☐ Reviewed
☐ Rejected
☒ Furnish as Corrected
☐ Revise and Resubmit
☐ Submit Specified Item

DRAWING TITLE
GENERAL NOTES

ARCHITECT : VERMONT AGENCY OF TRANSPORTATION
CUSTOMER : THE FORT MILLER CO., INC.
PROJECT : RIPTON FH 010-1(2) TH 18 OVER SOUTH BRANCH MIDDLEBURY RIVER
TOWN OF RIPTON, STATE OF VERMONT

Weld termination for steel members.

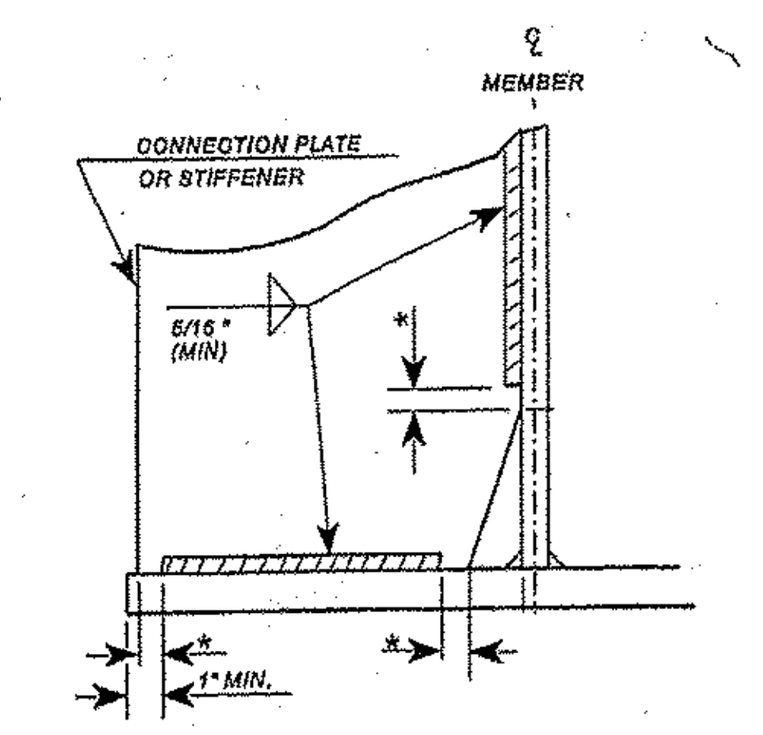
ADD VTRANS WELD TERMINATION DETAIL TO DRAWINGS

*NO WELD FOR 1/4" MIN. 1/2" MAX.
(EXCEPT MUST MAINTAIN 1" MINIMUM FROM EDGE OF FLANGE)
